ADDENDUM #2

**City of Sharonville, OH
Sharonville Fire Station #87 Renovation
11210 Reading Road, Sharonville, OH 45241
Hamilton County, OH
CT Project Number 170636
Issue Date: December 13, 2019**

INTERIOR ELEVATIONS

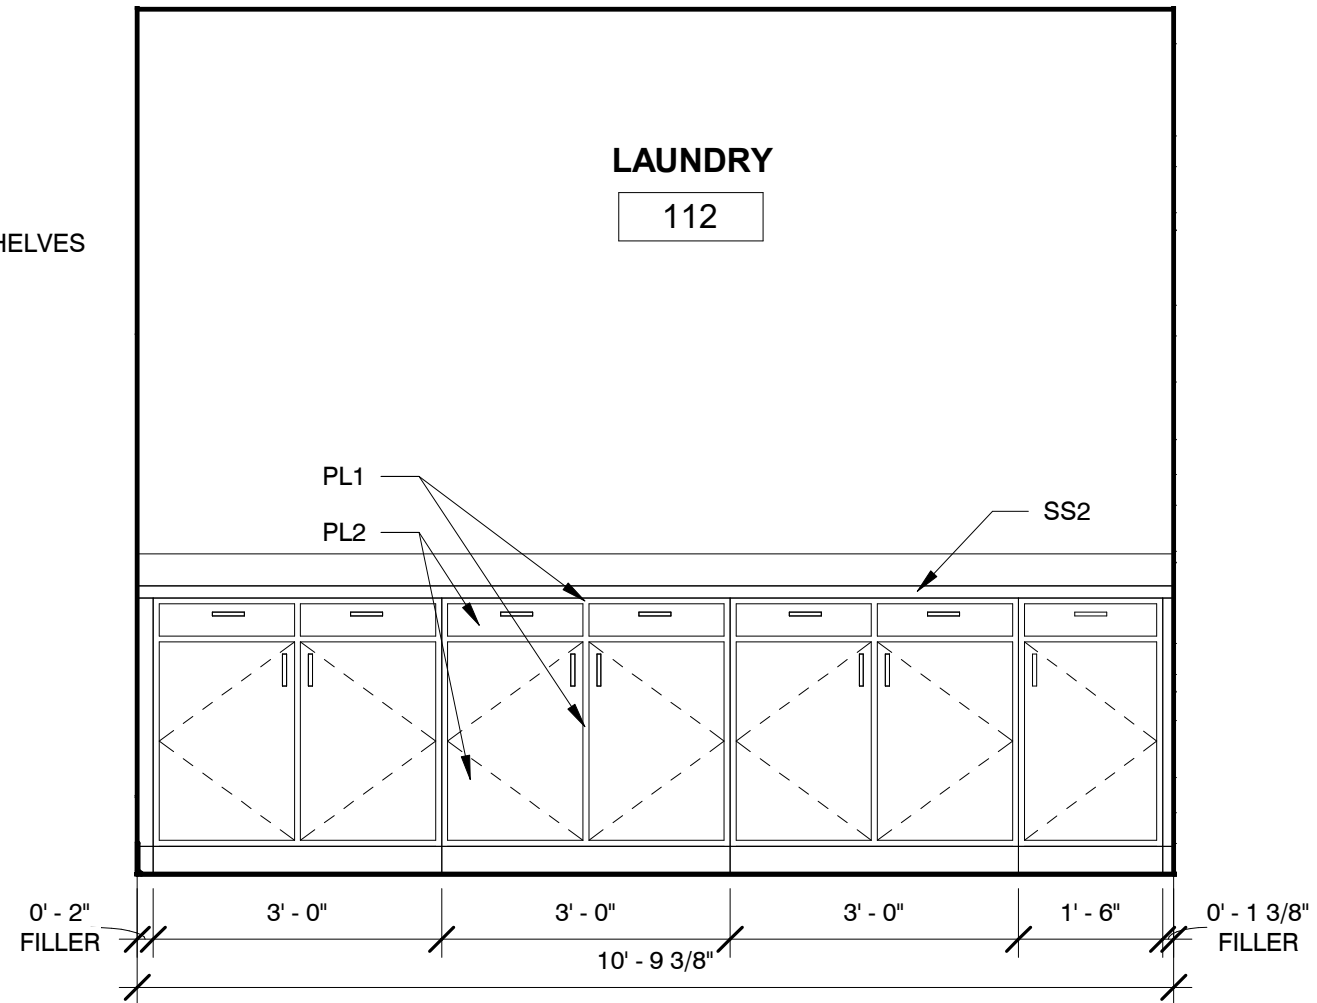
1. Drawing A101:
 - a. General Note "J" added: "Salvage and Return Cylinder Locksets to City"
2. Drawing A102:
 - a. Door 116 Wall Opening Graphics Change
 - b. Interior elevations added to Rooms 112, 113, 121 & 122 – Refer to Attached SK-1 sheet
 - c. Add Keynote to Rooms 121 & 113 shelving - 18" D. Wood Shelf with Melamine Finish @ 72" AFF. Provide metal support brackets @ 36" c/c
3. Drawing A201:
 - a. Corrected door graphics in Elevation 3/A201 – Door 200 now shows glazing for full lite doors – Door Type #2.
 - b. Corrected keynote on 6/A201 - Keynote 10.3 changes to 10.4.
4. Drawing A404:
 - a. Corrected Door Graphics on 1/A404 & 2/A404
5. Drawing M102:
 - a. 1.5 Hour rated Fire Dampers added to Detail 2/M-102– Mechanical Room
 - b. Air device tags updated

- 1) Clarifications and Follow-up:
 - a) Casework : Sheet A102 Rooms 121-122-113-112. There are no elevations for this case work on sheet A403. ***See attached new SK-1 supplemental drawing sheet addressing elevations and storage for rooms 112, 122. Add Keynote to Rooms 121 & 113 shelving – “18” D. Wood Shelf with Melamine Finish @ 72” AFF. Provide metal support brackets @ 36” c/c”.***
